BIURETENTION CELL UNDERDRAIN ELEVATION TABLE

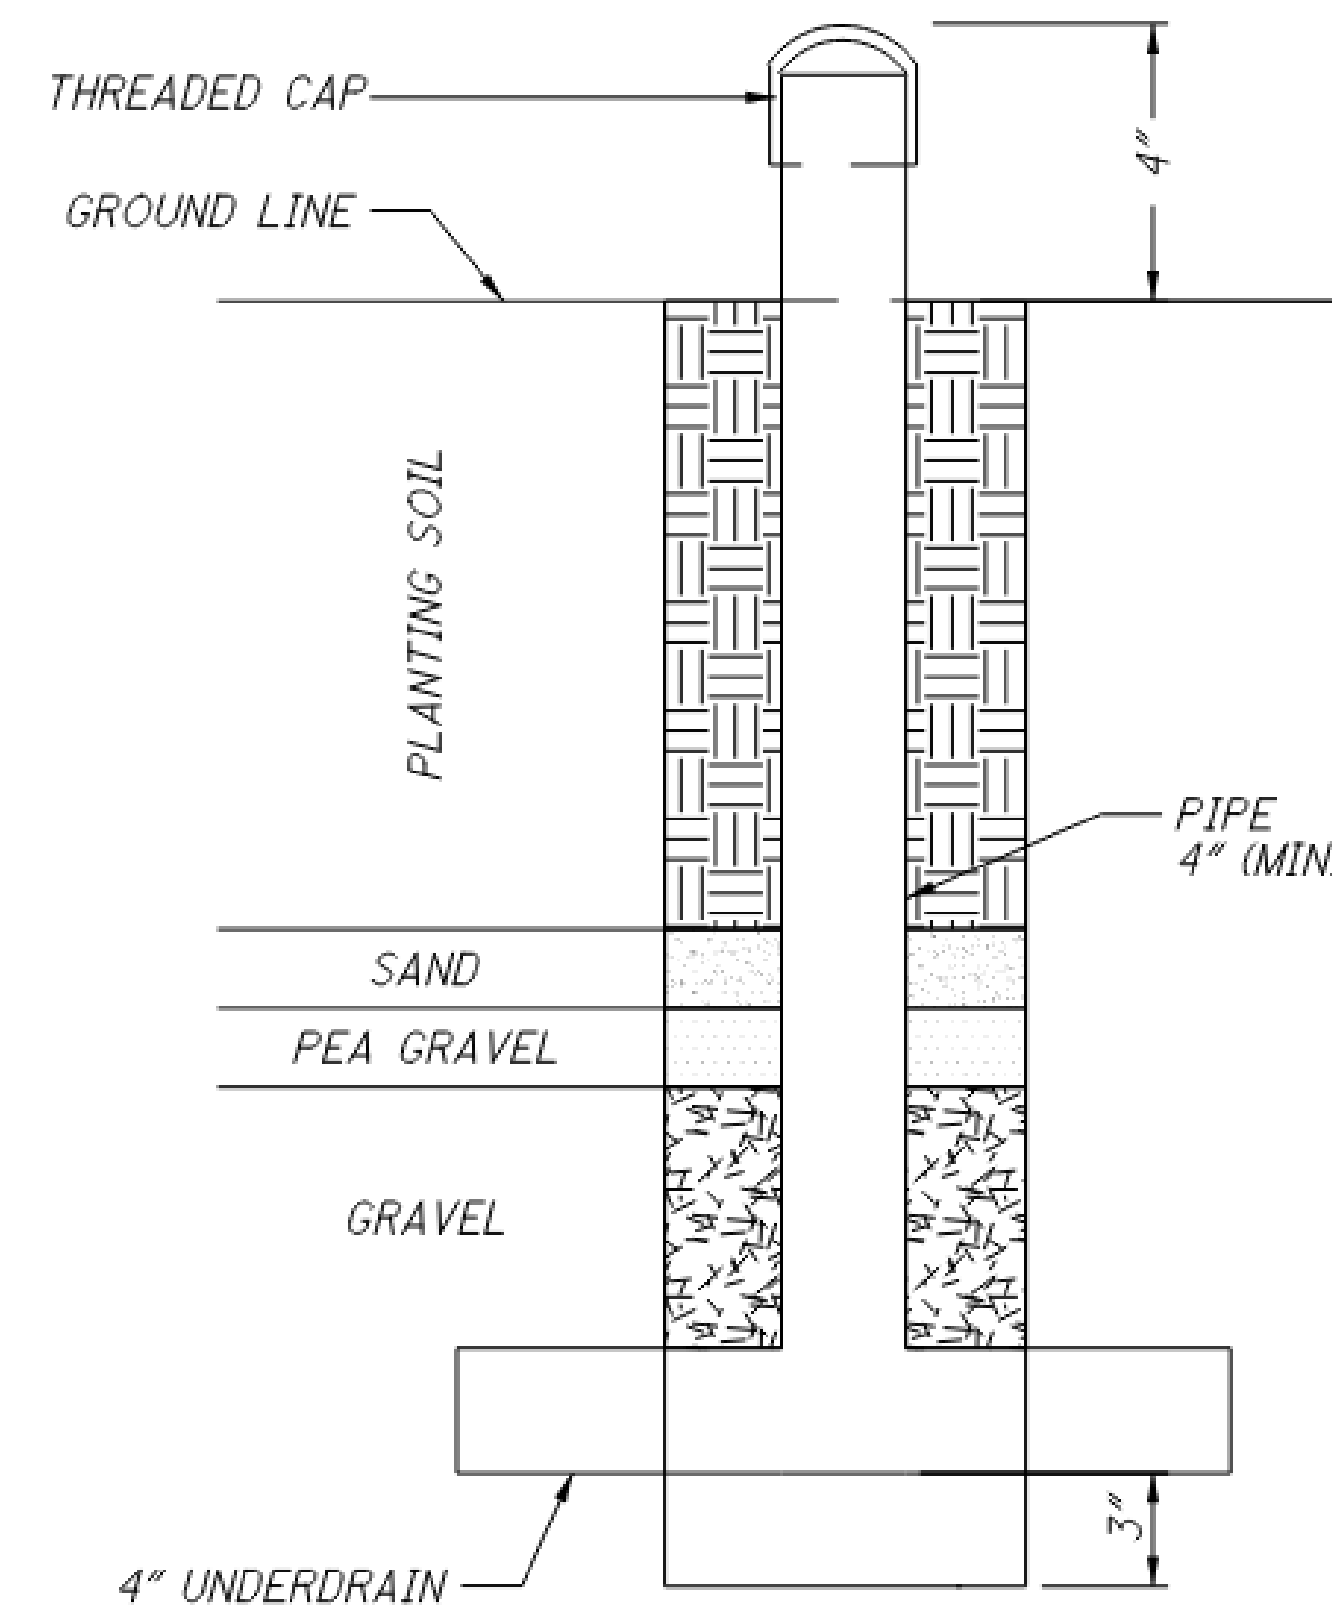
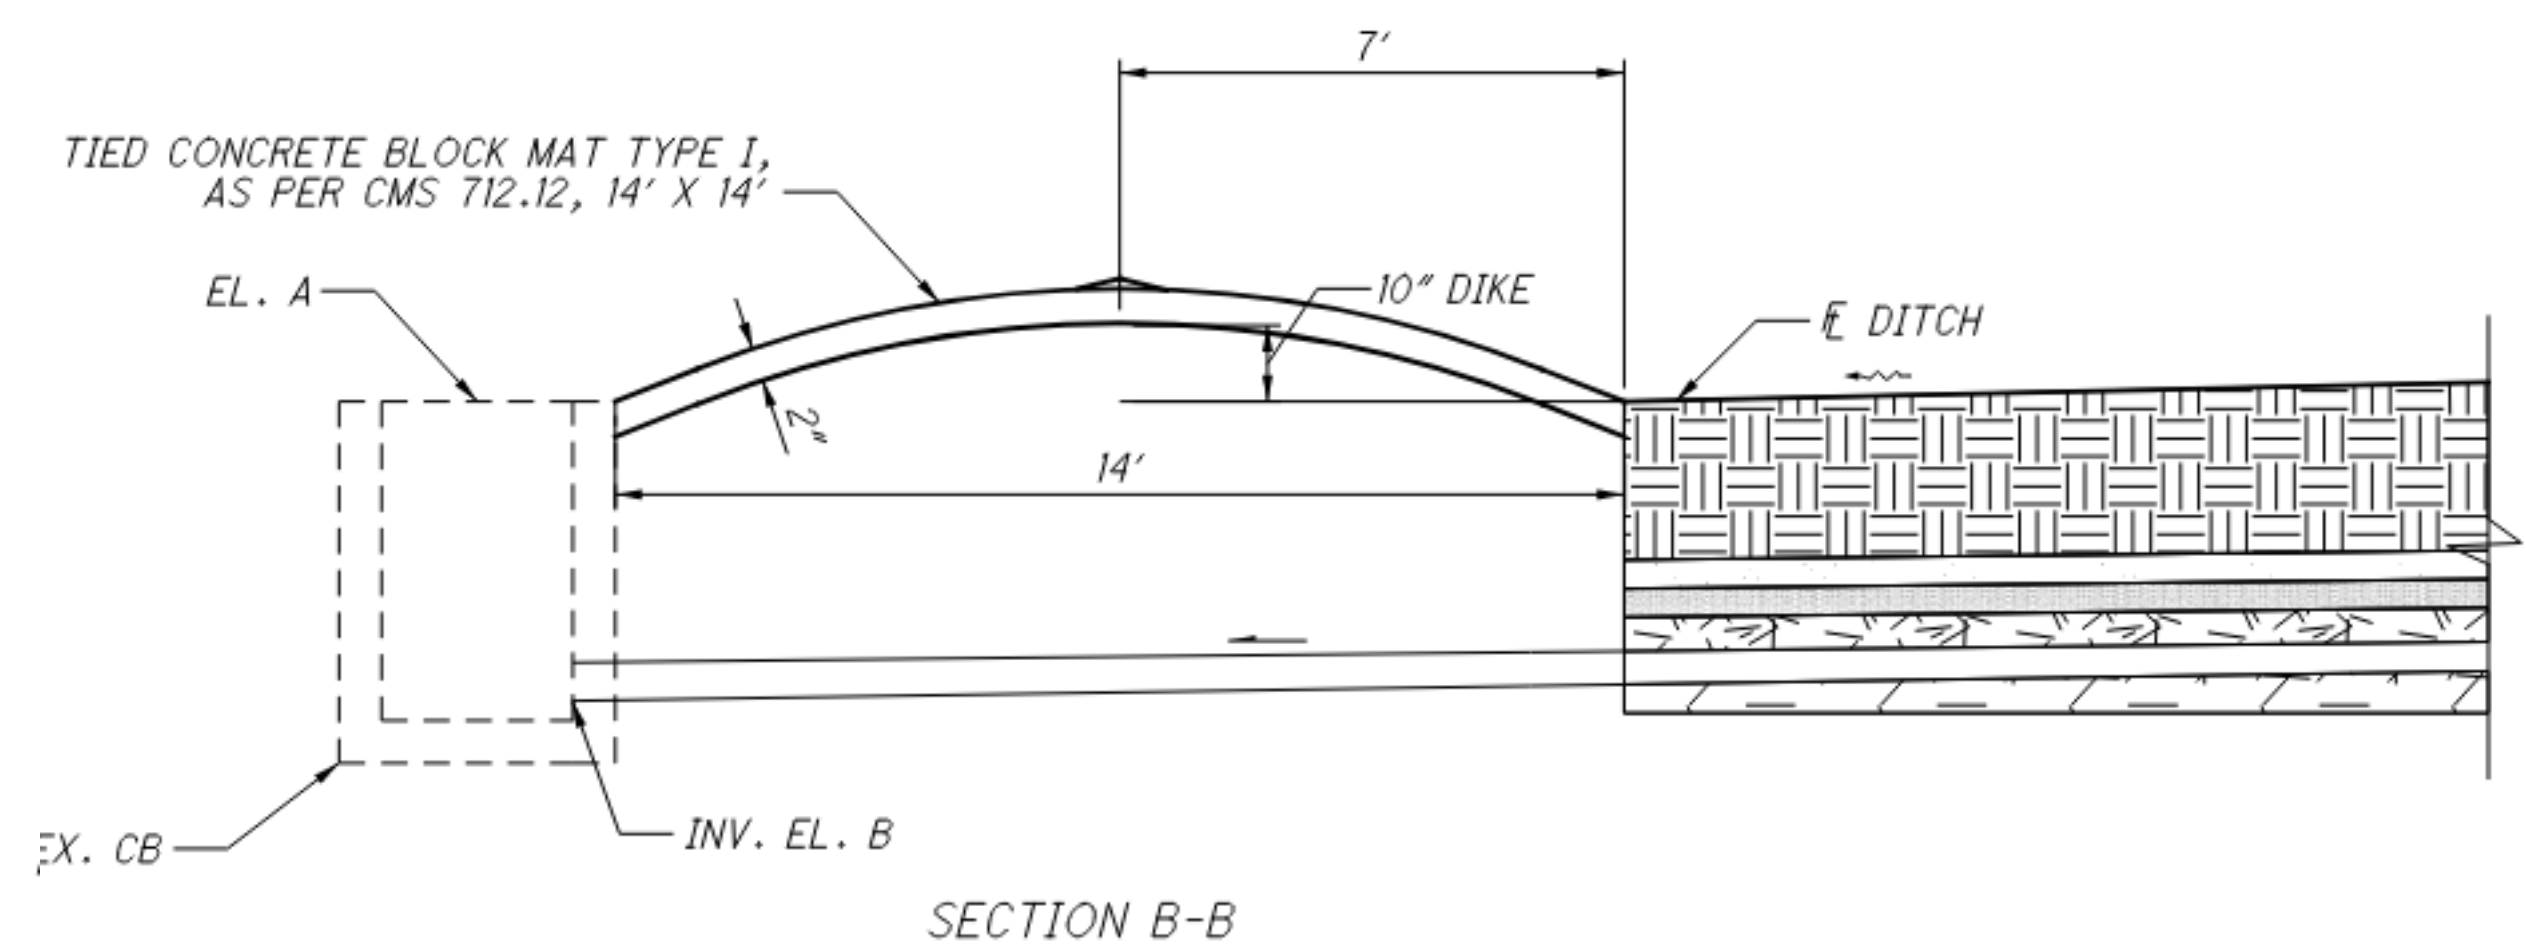
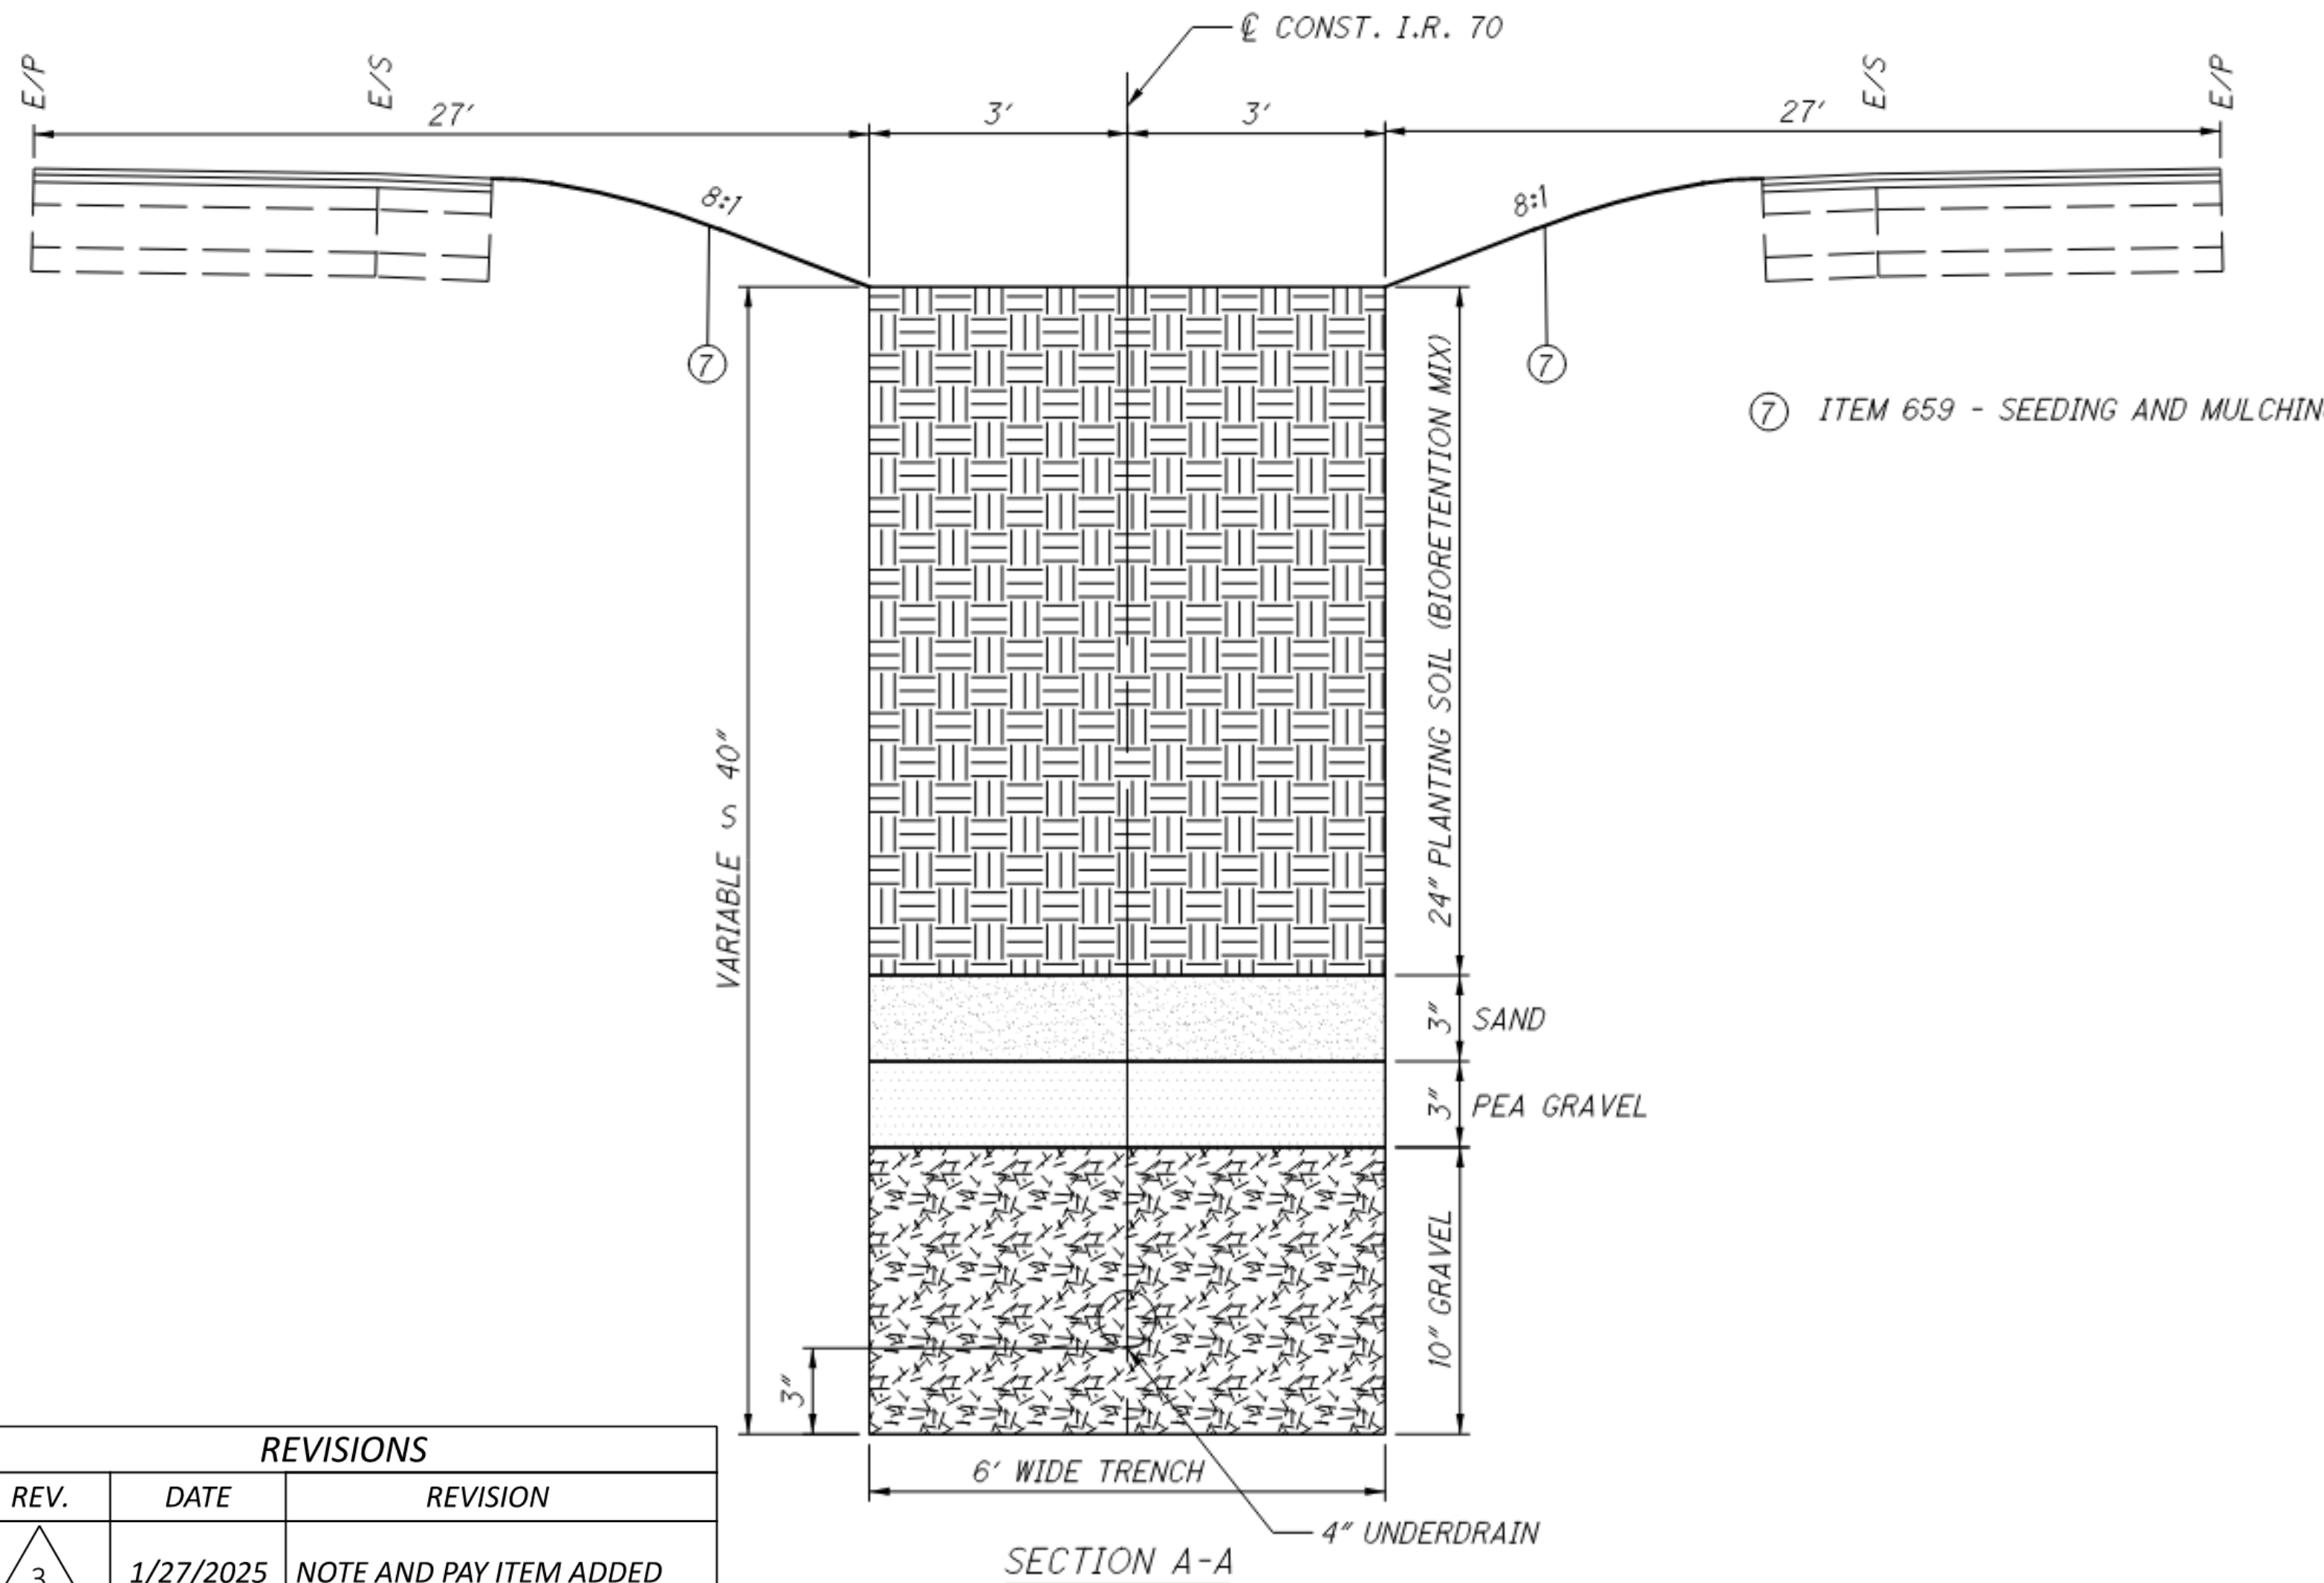
| REVISIONS | | |
|-----------|-----------|-------------------------|
| 3 | 1/27/2025 | NOTE AND PAY ITEM ADDED |

PROPOSED DIKES SHALL BE CONSTRUCTED AS SHOWN ON THIS SHEET AND PER ODOT CMS 712.12.

THE FOLLOWING ESTIMATED QUANTITY HAS BEEN CARRIED TO THE GENERAL SUMMARY FOR ITEM 601 - TIED CONCRETE BLOCK MAT WITH TYPE 1 UNDERLAYMENT:

ITEM 601 - TIED CONCRETE BLOCK MAT WITH TYPE 1 UNDERLAYMENT
 66 SY
